APV				THIS PRINT IS THE PROPERTY OF ADC. IT SHALL NOT BE COPIED WITHOUT PERMISSION.			TITLE					SYSTEM I/C					
DATE				MATERIAL			DWN PJK 7/18/96					DWG. NO. 1278-8000					REV
ECO																	
REV				FINISH			CHK RE 7/19/96					CO					
				-----			REL RE 7/19/96					D SCALE 1=1 SHEET 1 OF 1					
				4			3					2

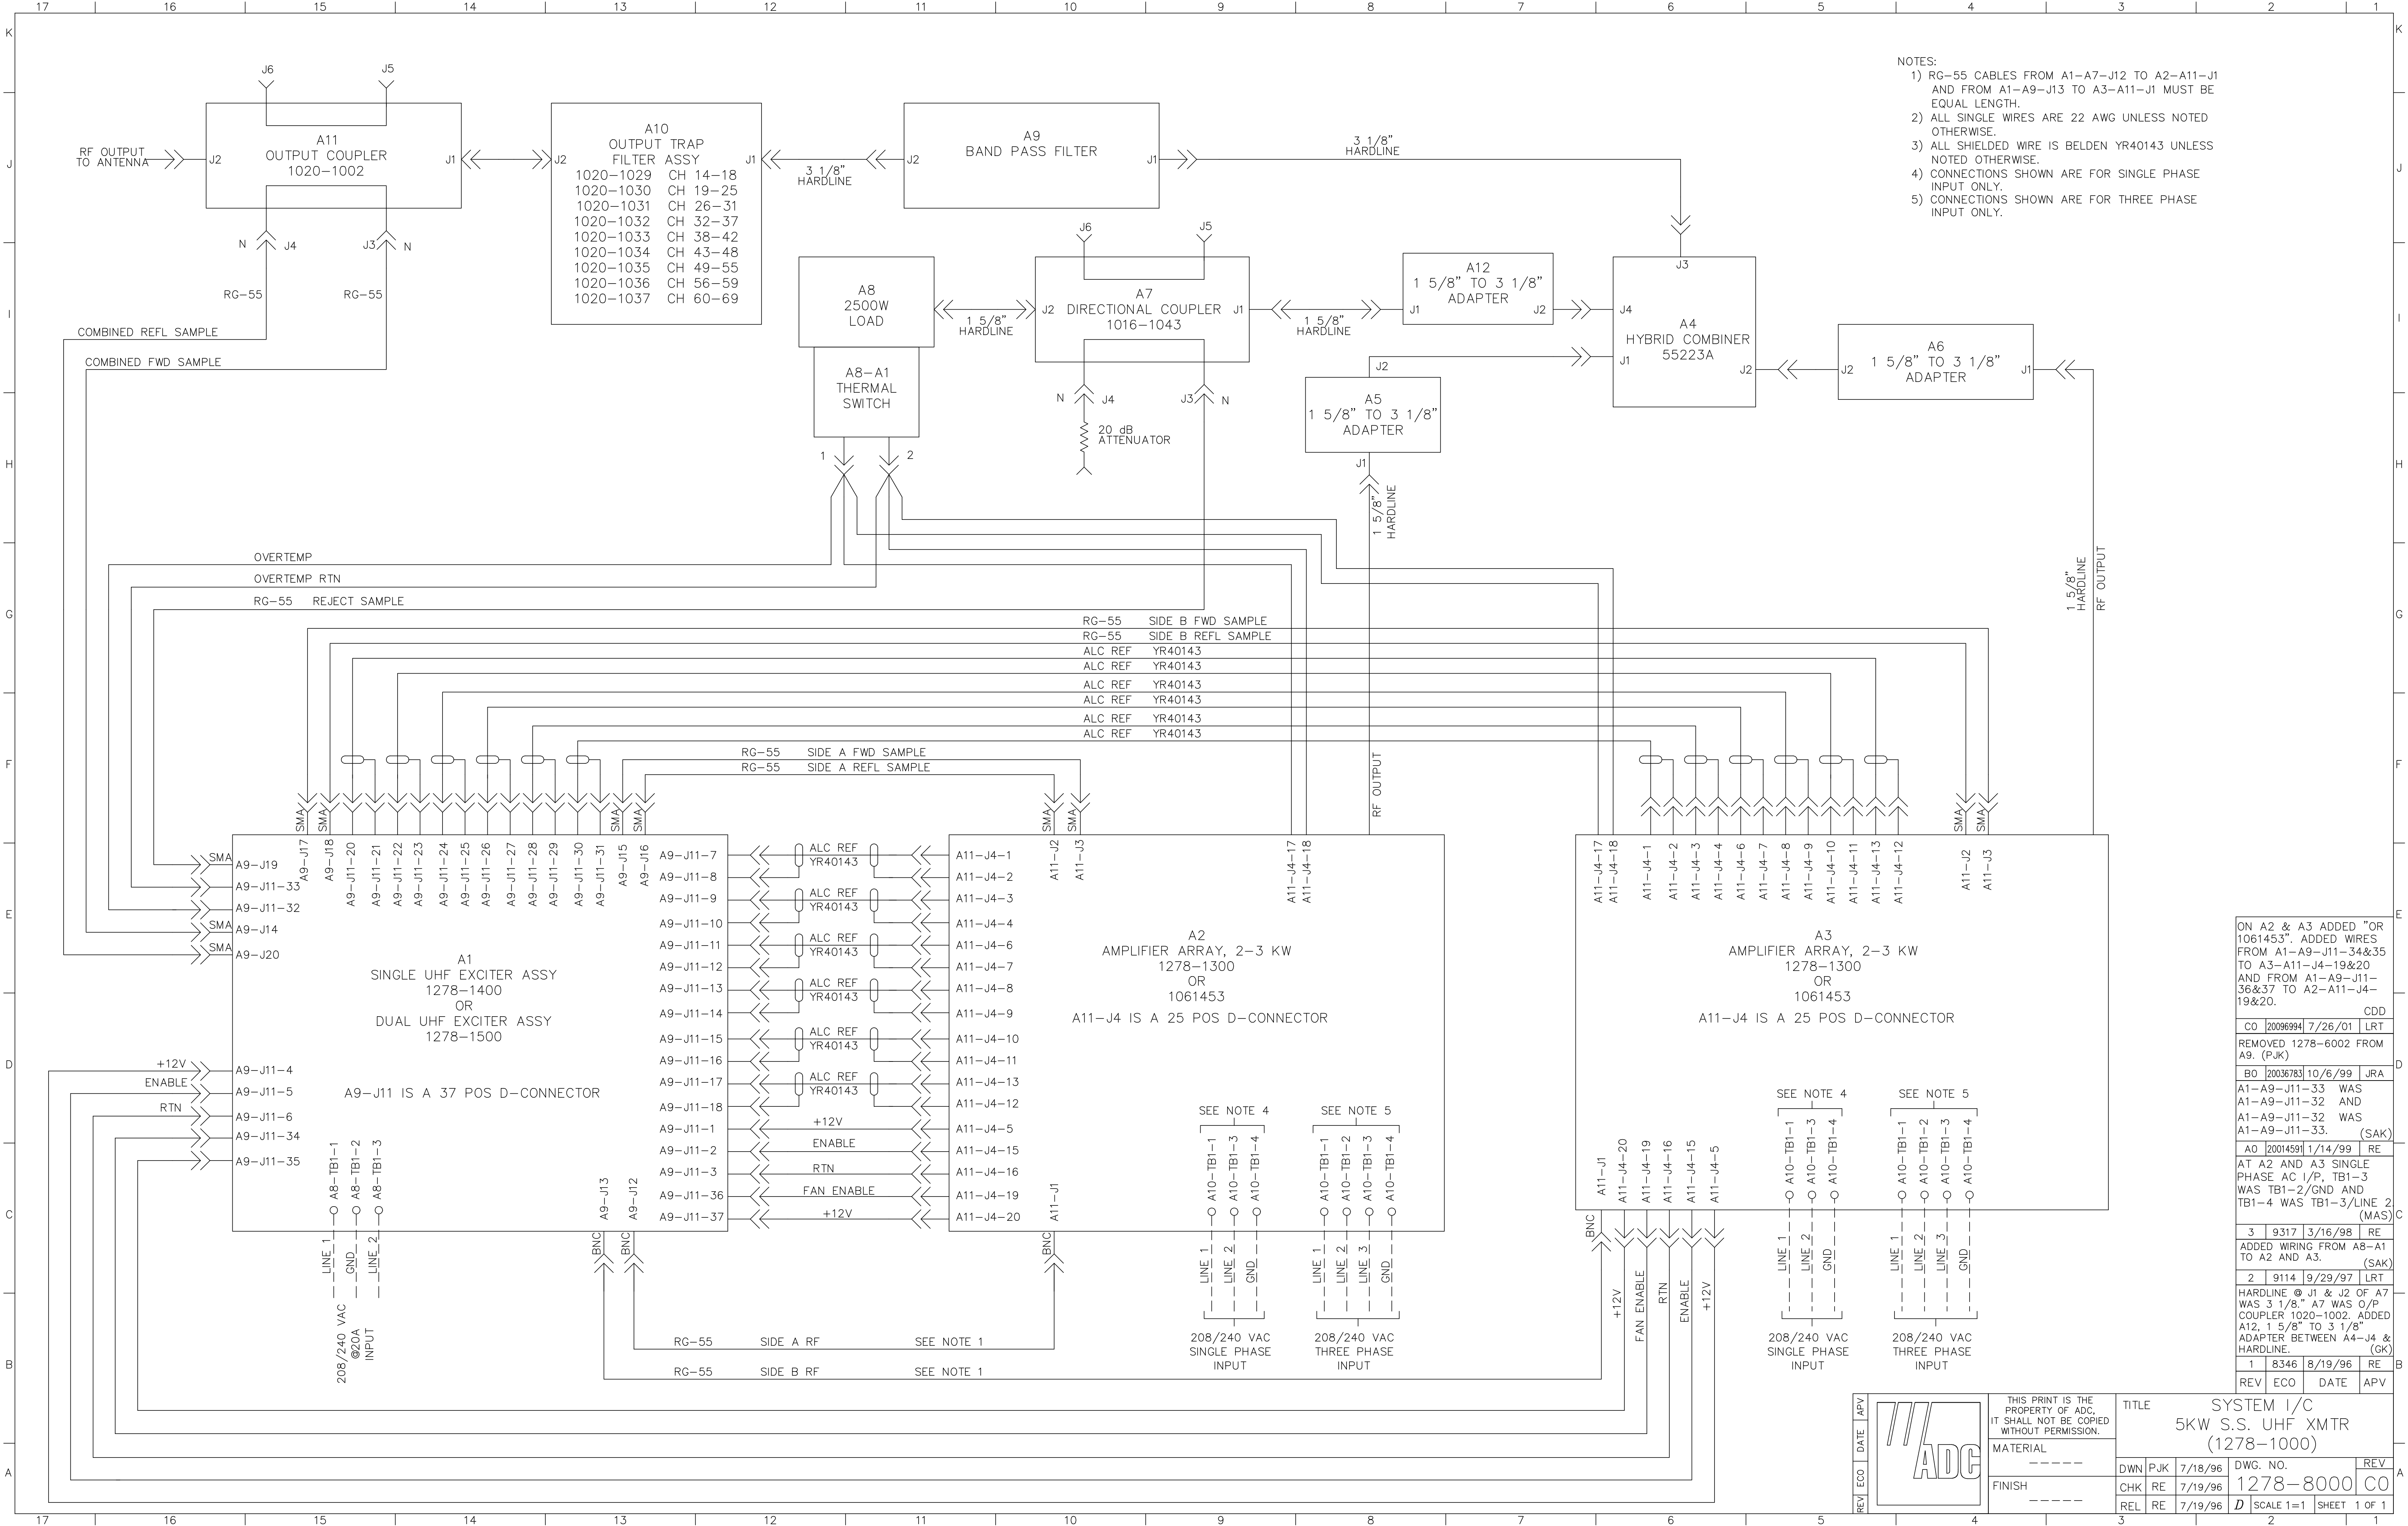
ON A2 & A3 ADDED "OR 1061453". ADDED WIRES FROM A1-A9-J11-34&35 TO A3-A11-J4-19&20 AND FROM A1-A9-J11-36&37 TO A2-A11-J4-19&20.				CDD
CO	20086994	7/26/01	LRT	
REMOVED 1278-6002 FROM A9. (PJK)				
BO	20036783	10/6/99	JRA	
A1-A9-J11-33 WAS A1-A9-J11-32 AND A1-A9-J11-32 WAS A1-A9-J11-33. (SAK)				
AO	20014591	1/14/99	RE	
AT A2 AND A3 SINGLE PHASE AC I/P, TB1-3 WAS TB1-2/GND AND TB1-4 WAS TB1-3/LINE 2 (MAS)				
3	9317	3/16/98	RE	
ADDED WIRING FROM A8-A1 TO A2 AND A3. (SAK)				
2	9114	9/29/97	LRT	
HARDLINE @ J1 & J2 OF A7 WAS 3 1/8". A7 WAS O/P COUPLER 1020-1002. ADDED A12, 1 5/8" TO 3 1/8" ADAPTER BETWEEN A4-J4 & HARDLINE. (GK)				
1	8346	8/19/96	RE	
REV	ECO	DATE	APV
